RE: **Lot 10 Block 1 Volcano Cliffs Unit 22 SAD 228**
8004 Alto Rey Ct. NW
Grading and Drainage Plan
Engineers Stamp Date 10/21/2020 (D10D003N11)
Pad Certification Dated: 5/10/2021

Based upon the information provided in your submittal received 6/25/2021, this plan is approved for Building Permit.

**Re: Pulte at Volcano Cliffs Unit 18
Erosion and Sediment Control Plan
Engineer's Stamp Date 6/17/2021 (D10E003_P)**

Based upon the information provided in your submittal received 6/16/2021, the above referenced plan is approved to be included in the SWPPP and Building Permit plans.

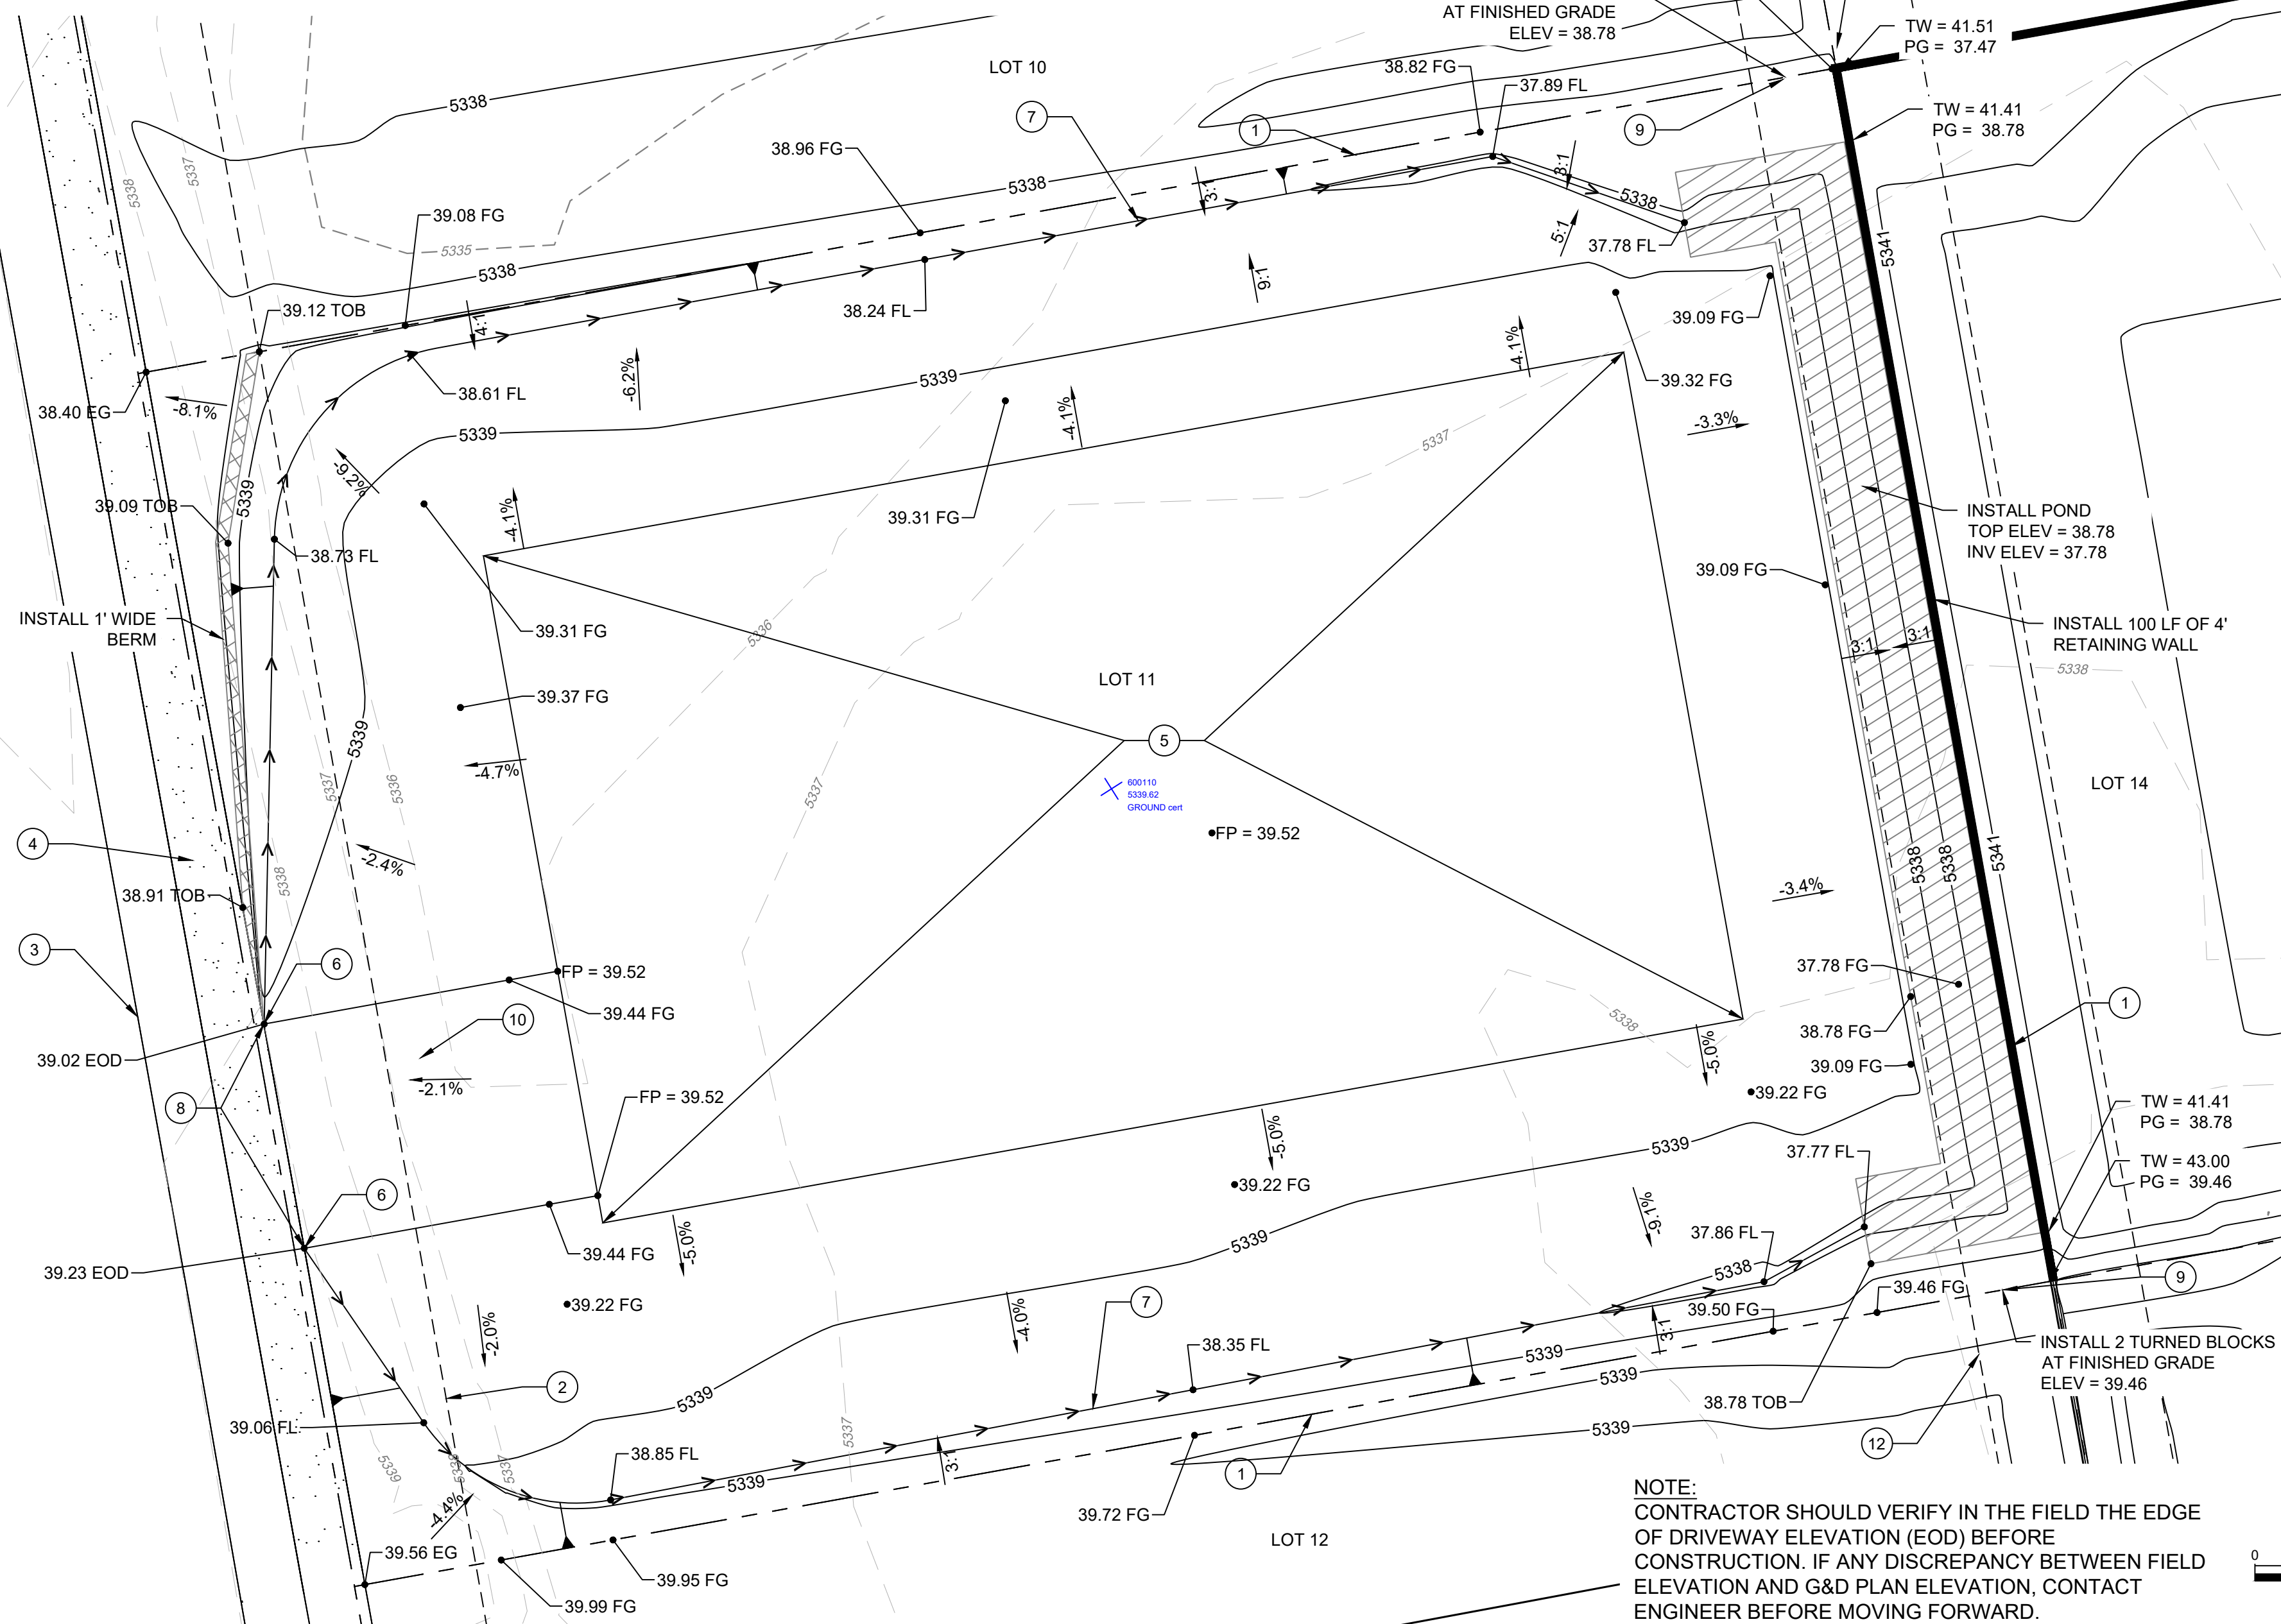
Reiterate to the Owner/Contractor that a separate permit for a garden/retaining wall must be obtained with the approved G&D plan and Pad Certification. **Also, if a swimming pool is to be placed the grading and drainage plan will change and will need to be resubmitted showing location of pool and land treatment changes.**
